# Access Compliance Report

## Public Rights-of-Way

### (Curb Ramps)

Intersection ID: 30513	Main Street: S_TRYON_ST	Cross Street: GENERAL_DR	Location: SE
ADA ID: 228F0FA16259	Ramp Type: PerpDiag	Initial Pass/Fail: Fail	Overall Compliance: No
Severity Score: 21.25			
Codes/Mitigation Info/Possible Solution		Field Measurements/Component Compliance

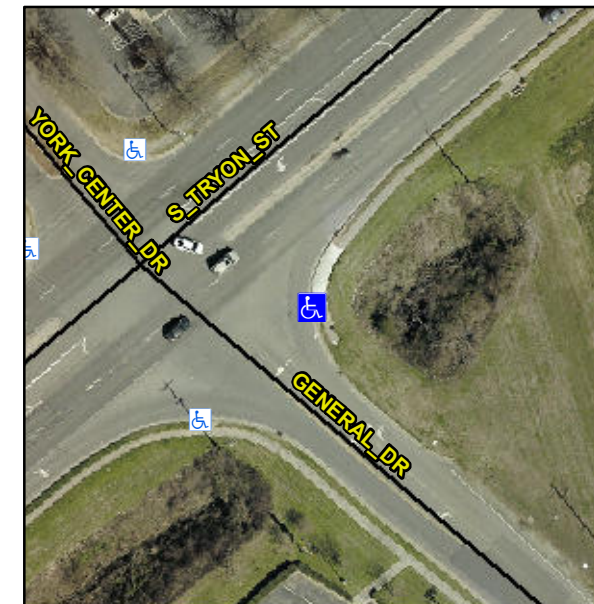
**R304.5.1, R304.2.2**

Compliance	Description	Data	Compliance	Description	Data
N/A	Ramp Length (in)	90.0	No	Ramp Slope (%)	8.6
No	Ramp Width (in)	44.0	Yes	Ramp XSlope (%)	1.8
N/A	Flare Type LT	N/A	N/A	Flare Type RT	N/A
N/A	Flare Slope LT (%)	N/A	N/A	Flare Slope RT (%)	N/A
N/A	Flare Traversable LT?	N/A	N/A	Flare Traversable RT?	N/A
N/A	Landing Length (in)	N/A	N/A	DWS Provided?	N/A
N/A	Landing Width (in)	N/A	N/A	DWS Contrast?	N/A
N/A	Landing Slope (%)	N/A	N/A	DWS Length (in)	N/A
N/A	Landing X Slope (%)	N/A	N/A	DWS Full Width?	N/A
N/A	Landing Curb? (Y/N)	N/A	N/A	DWS Offset (in)	N/A
N/A	Shared Landing?	N/A			
N/A	Gutter Ponding?	N/A	N/A	Gutter Slope (%)	N/A
N/A	Gutter Lip Ht (in)	N/A	N/A	Gutter X Slope (%)	N/A
N/A	Painted X Walk1?	No	N/A	Painted X Walk2?	No
	X Walk 1 Direction	To NW		X Walk 2 Direction	To SW
N/A	X Walk 1 Width (in)	N/A	N/A	X Walk 2 Width (in)	N/A
	X Walk 1 Slope (%)	0.5		X Walk 2 Slope (%)	2.2
	X Walk 1 X Slope (%)	2.3		X Walk 2 X Slope (%)	1.2

**Remove & Replace Curb Ramp With Two New Directional Ramps or Equivalent.**
